RB175-07/08

RB176-07/08

RB177-07/08

FIGURE R614.5(5) (Supp)
SIP WALL TO WALL PLATFORM FRAME CONNECTION

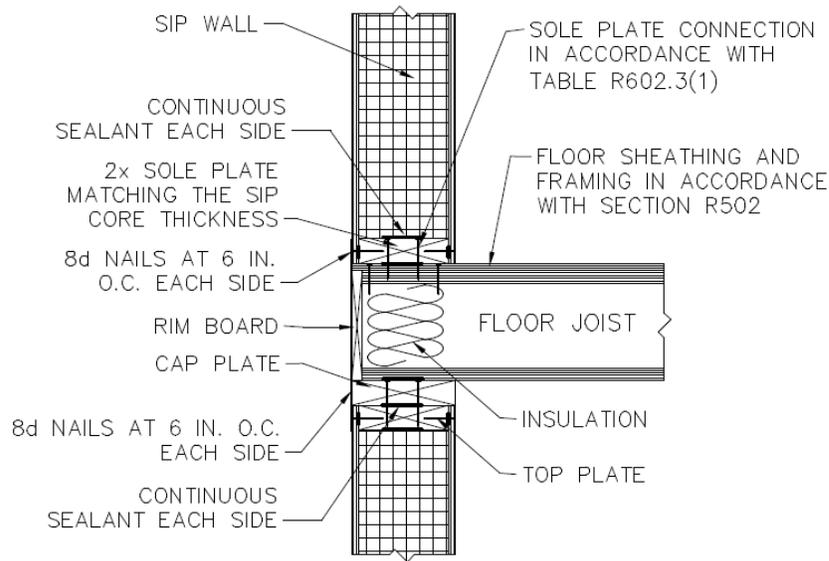
5. Delete figure and substitute as follows:

(Figures illustrate SIP-specific attachment requirements. Other connections shall be made in accordance with Table R602.3(1) and (2) as appropriate.)

- In Figures R614.5(5) and (6) a note was added that SIP-specific connections only were shown and additional requirements of Tables R602.3(1) and (2) shall also be applied as appropriate.

FIGURE R614.5(6) (Supp)
SIP WALL TO WALL BALOONBALLOON FRAME CONNECTION – I-JOIST FLOOR SHOWN FOR ILLUSTRATIVE PURPOSES ONLY.

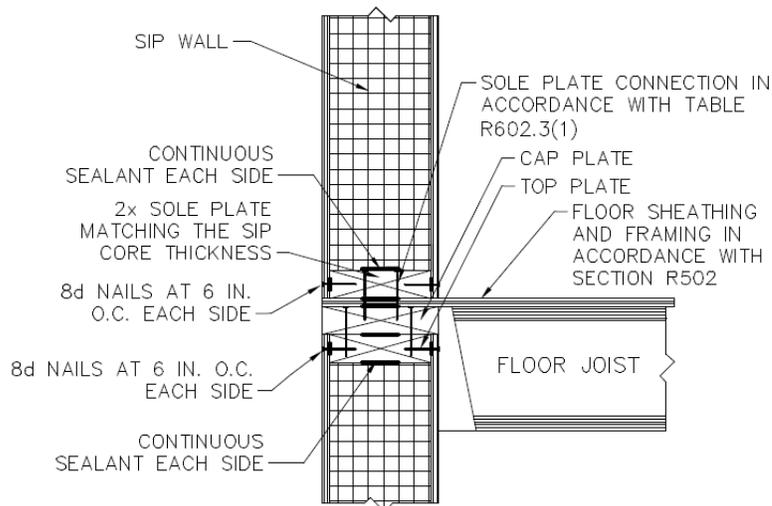
6. Delete figure and substitute as follows:

(Figures illustrate SIP-specific attachment requirements. Other connections shall be made in accordance with Table R602.3(1) and (2) as appropriate.)

**FIGURE R614.5.1 (Supp)
SIP WALL FRAMING CONFIGURATION**

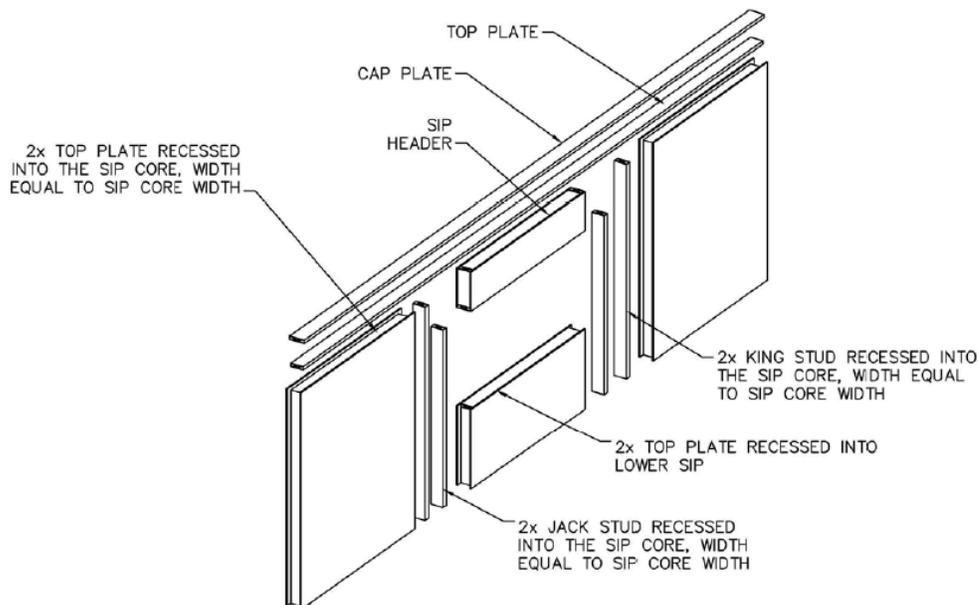
7. Delete figure and substitute as follows:

1. Top plates shall be continuous over header.
2. Lower 2 x top plate shall have a width equal to the SIP core width and shall be recessed into the top edge of the panel. Cap plate shall be placed over the recessed top plate and shall have a width equal to the SIPs panel width.
3. SIP facing surfaces shall be nailed to framing and cripples with 8d common or galvanized box nails spaced 3 @ inches on center. ~~staggering alternate nails 1/2 inch.~~
4. Galvanized nails shall be hot-dipped or tumbled. Framing shall be attached in accordance to R602.3(1) unless otherwise provide for in Section R614.

- Figure R614.5.1 was modified to more clearly illustrate the cap plate and footnote 2 was added to explain the difference between the cap plate and bottom plate of the double top plates. Appropriate corrections were made to Footnote 3, as there is not requirement for double rows of nailing in the prescriptive standard.

FIGURE R614.8 (Supp)
TYPICAL SIP SPLICING CONNECTION DETAILS FOR VERTICAL IN-PLANE JOINTS

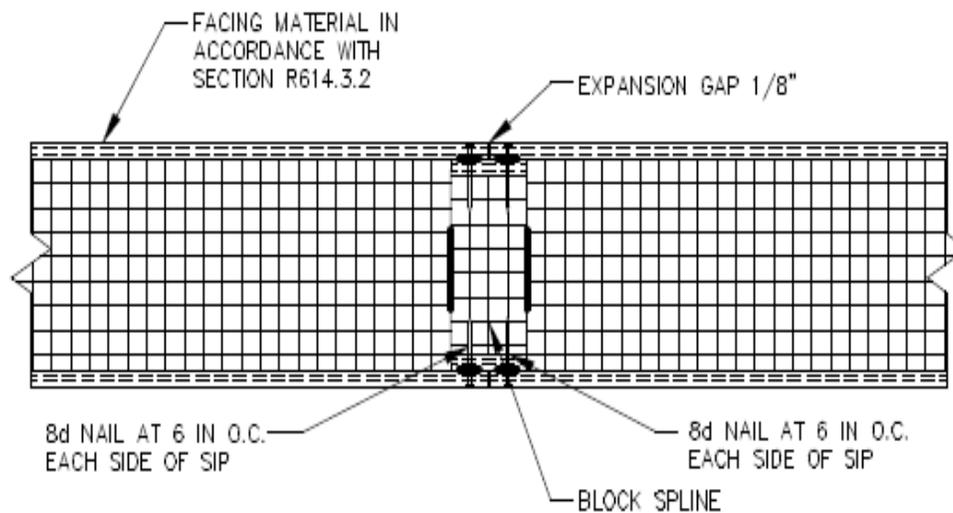
10. Delete figure and substitute as follows:

- Figure R614.8 was modified to show both types of generic connection details appropriate for the prescriptive method.

FIGURE R614.9 (Supp)
SIP CORNER FRAMING DETAIL

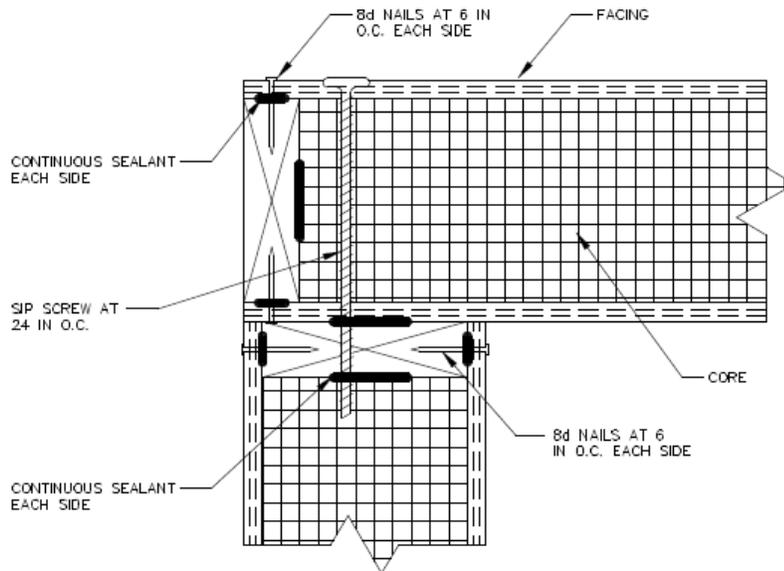
12. Delete figure and substitute as follows:

- Figure R614.9 was modified to show additional penetration of SIP screw.

FIGURE R614.5(3)
TRUSSED ROOF TO TOP PLATE CONNECTION

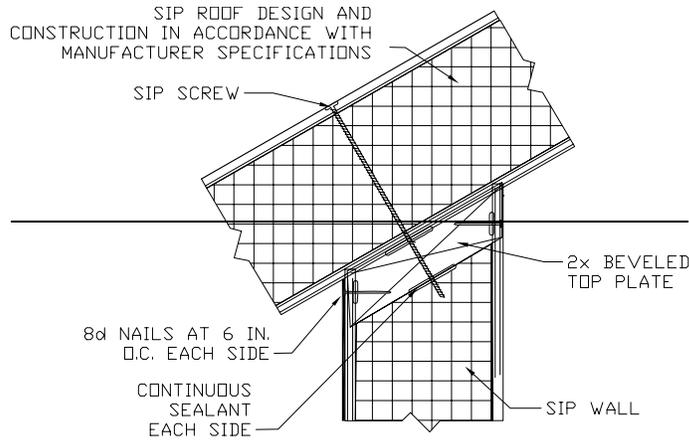
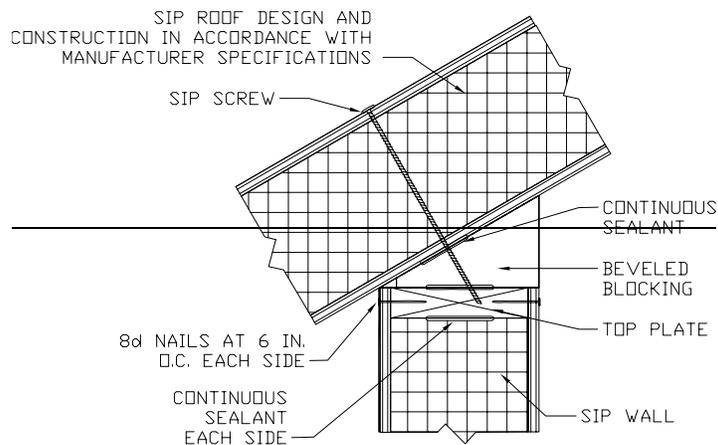
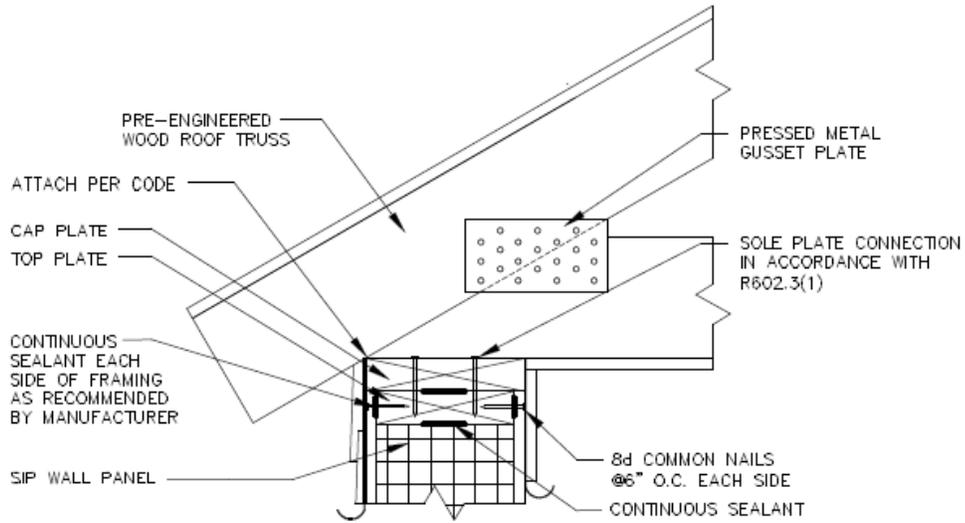
1. Delete Figures R614.5(3) and R614.5(4) and substitute the single new Figure R614.5(3) as follows:

Reason: The purpose of this change proposal is to clarify the IRC. The figures proposed for deletion showed SIP roof panels attached to SIP wall panels. The purpose of this section was exclusively SIP wall panels and it was thought that showing SIP roof panels would confuse the issue. In lieu of the two SIP roof panel figures a truss roof is proposed as this was the most likely roof system used for SIP prescriptive wall panels.

FIGURE R614.5(1)
MAXIMUM ALLOWABLE HEIGHT OF SIP WALLS

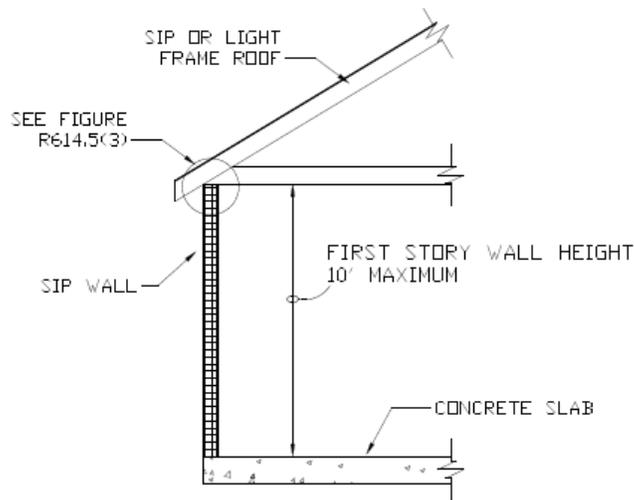
2. Delete and substitute as follows:

**FIGURE R614.5(2)
MAXIMUM ALLOWABLE HEIGHT OF SIP WALLS**

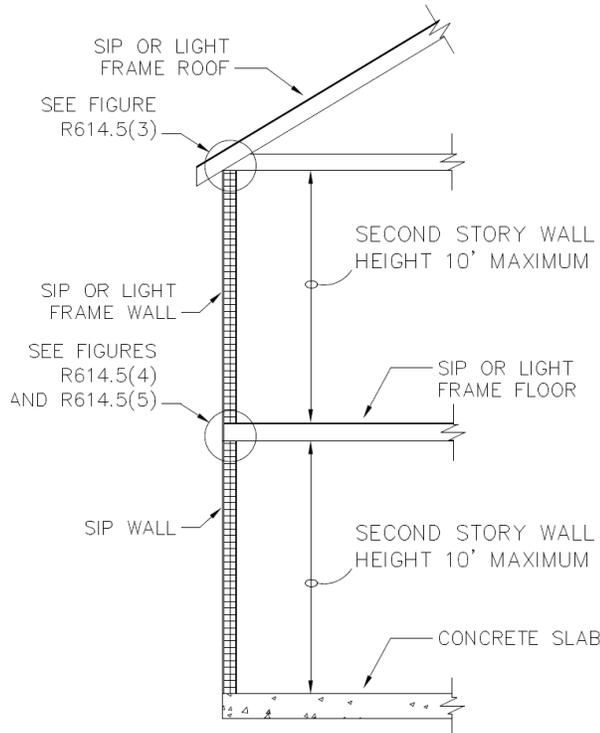
3. Delete and substitute as follows:

FIGURE R804.1.2
IN-LINE FRAMING

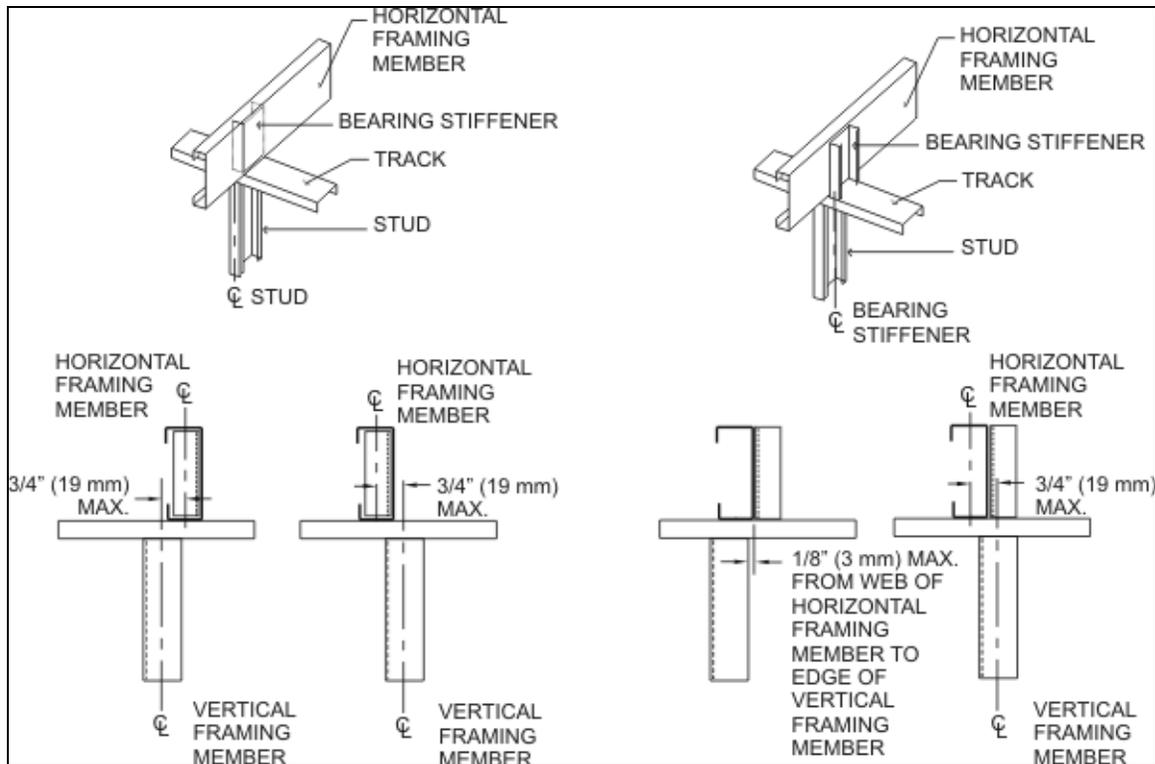
23. Add new figure as follows:

Section R804.1.2: The 2007 edition of AISI S230 references the 2007 edition of AISI S200 (*North American Standard for Cold-Formed Steel Framing—General Provisions*) which has revised the in-line framing tolerance to account for the special case of the bearing stiffener located on the back-side of the joist. This was based on research at the University of Waterloo (Reference: Fox, S.R. (2003), "The Strength of Stiffened CFS Floor Joist Assemblies with Offset Loading," American Iron and Steel Institute, Washington, D.C.)

FIGURE R804.2.5.3
WEB HOLE PATCH

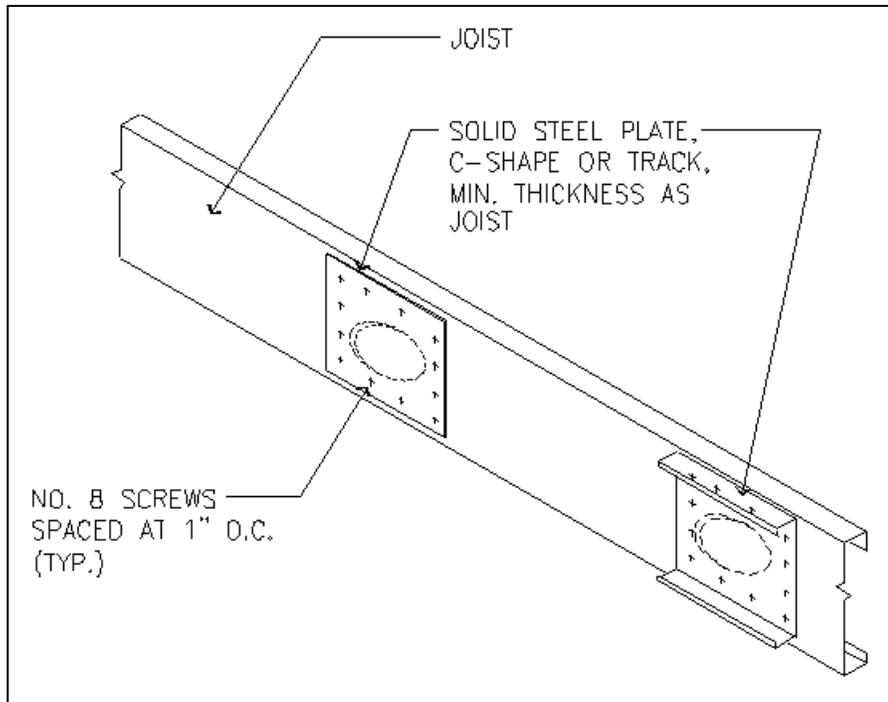
25. Add new figure as follows:

FIGURE R804.3.1.1(1)
JOIST TO RAFTER CONNECTION

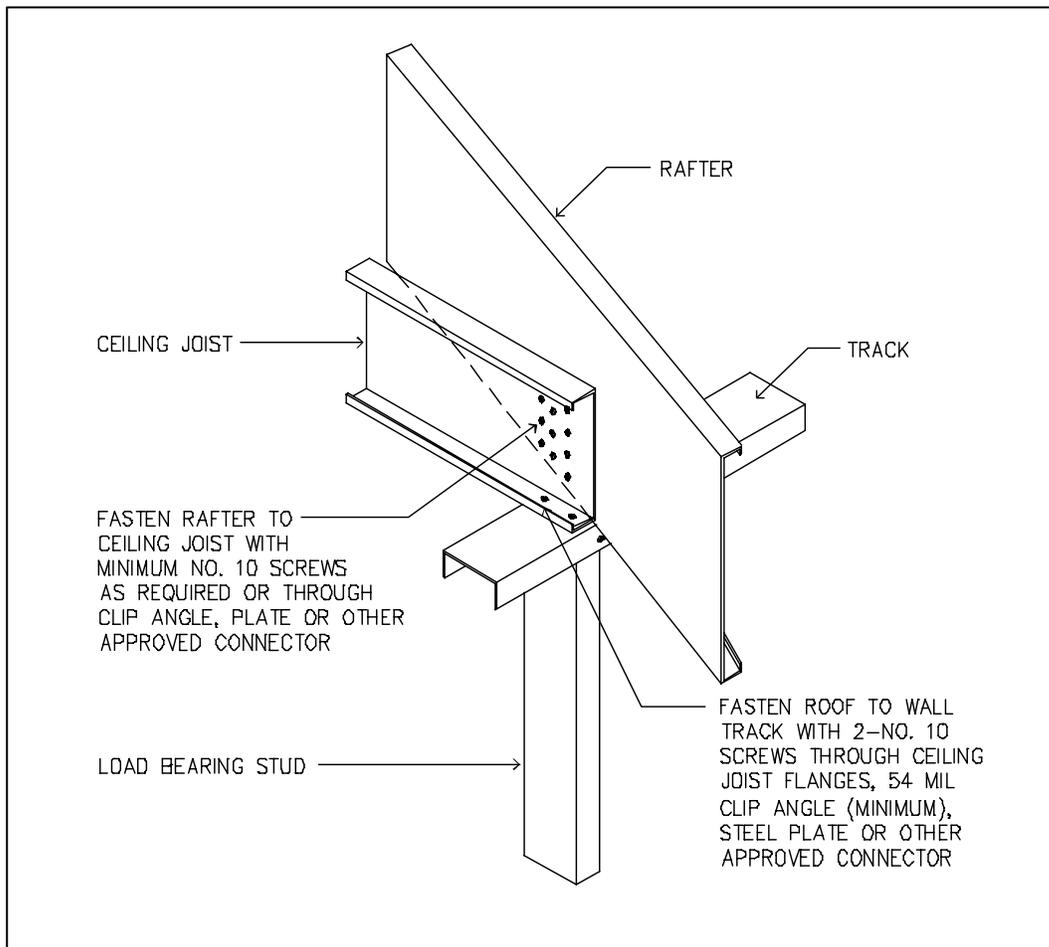
27. Delete existing Figure R804.3.1(1) and replace as follows:

FIGURE R804.3.6(2)
HEADER TO TRIMMER CONNECTION

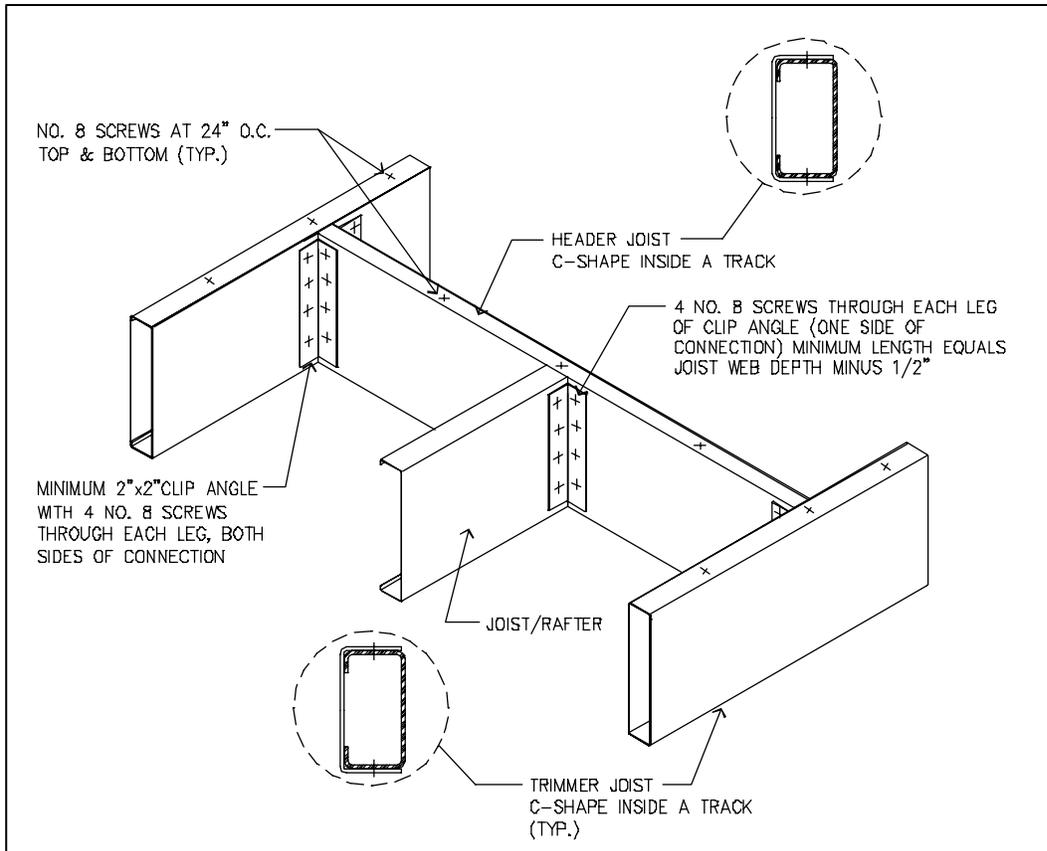
33. Delete existing Figure R804.3.10(2) and substitute as follows:

Section R804.3.6 (new): This section on framing of openings has been updated to reflect the latest provisions from AISI S230, including the addition of a new figure.
